DECISION OF THE QUEENSTOWN LAKES DISTRICT COUNCIL

CHANGE OF CONSENT NOTICE CONDITIONS UNDER SECTION 221

Applicant:	McWhirter Trust
RM reference:	RM171048
Application:	Application under Section 88 of the Resource Management Act 1991 (RMA) to undertake a 3 lot subdivision, to establish a residential building platform on the two new lots, and to change conditions of consent notice 5081454.6; specifically bullet point 2 regarding previously approved landscaping and “Landscape Guidelines”, and bullet point 7 to enable further subdivision of the site
Location:	1224 Gibbston highway, Wakatipu Basin
Legal Description:	Lot 4 Deposited Plan300878 held in Computer Freehold Register 4170
Operative Zoning:	Rural General
Proposed Zoning;	Wakatipu Basin Rural Amenity Zone (WBRAZ) (Stage 2 Rural Zone variation)
Activity Status:	Discretionary
Notification Decision:	Publicly Notified
Delegated Authority:	Quinn McIntyre – Manager, Resource Consents
Final Decision:	Granted Subject To Conditions
Date Decisions Issued:	23 February 2018

ANNEXURE 1 COUNCIL'S S42A PLANNING REPORT

Scheme Plan

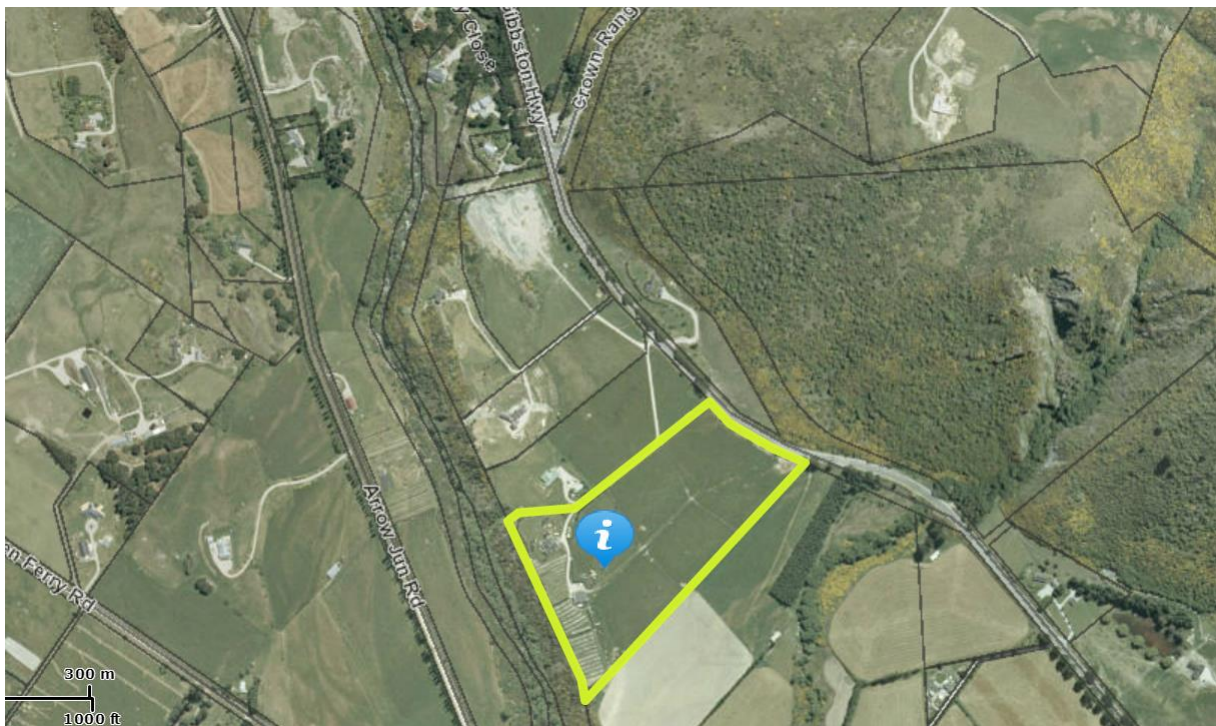
Comments		
	Existing Use	Grazed paddock land with dwelling and sheds on proposed Lot 3
	Neighbours	A single rural dwelling to the north-west. All other land currently paddocks.
	Topography/Aspect	Flat topography
	Water Bodies	Royal Burn located approximately 250 m to the south-east

ENGINEERING	COMMENTS	Condition
<p>Means of Access</p>	<p><u>Vehicle Crossing to SH6</u> There is an established vehicle crossing off State Highway 6 which provides access to four dwellings, including the existing dwelling on the subject site, as well as to the Millbrook quarry. It is proposed that the additional 2 lots will also use this existing vehicle crossing and the Right of Way (ROW), which currently provides access to residences at 1220 Gibbston Highway and 1224 Gibbston Highway. The existing vehicle crossing is generally formed to a NZTA Diagram E standard and is consistent with Diagram 3: Private Access (Frequent use by heavy vehicles) contained in Appendix 7 of the Queenstown Lakes District Plan. NZTA has assessed the application and provided its Affected Persons Approval and therefore I am satisfied that this access crossing is sufficient.</p> <p><u>Existing Access ROW</u> Access from the SH6 vehicle crossing to the existing dwelling on proposed Lot 3 is via an existing formed ROW. The carriageway itself is formed as a 2.5-3 m wide gravel track with 1.5 m wide grassed shoulders on either side. The applicant proposes to access the new building platforms on Lots 1 & 2 from this existing ROW.</p> <p>The applicable Council standard for formation of this access is figure E2 of Table 3.2 of the QLDC Subdivision Code of Practice. This standard requires a 2.5 m wide carriageway with provision for passing every 50 m. I am satisfied that the current formation meets or exceeds 2.5 m and the soft shoulders provide sufficient width for two vehicle to pass at any point if required. This access ROW is currently formed in gravel and I am satisfied that it is appropriate for it to remain unsealed as the number of vehicle movements are limited and maintenance is dealt with via easement agreement.</p> <p><u>New Access to Lots 1 & 2</u> To access the new building platforms on Lots 1 & 2 the applicant proposes a new 4 m wide legal ROW and minimum 2.5 m wide carriageway from the existing main formed ROW. From the new section of ROW a private driveway will be installed to each individual building platform. I am satisfied that the proposed new accesses to the building platforms can feasibly meet QLDC standards. To ensure access to the platforms are suitably provided, I recommend a consent condition that prior to the commencement of works the consent holder shall provide detailed design plans for the provision of an access way to each building platform in accordance with Council standards.</p> <p>To ensure right-of-way easements are secured I recommend a consent condition that at time of 223 all required easements shall be shown in the Memorandum of Easements attached to the Survey Plan and shall be duly granted or reserved.</p>	<p>x</p>
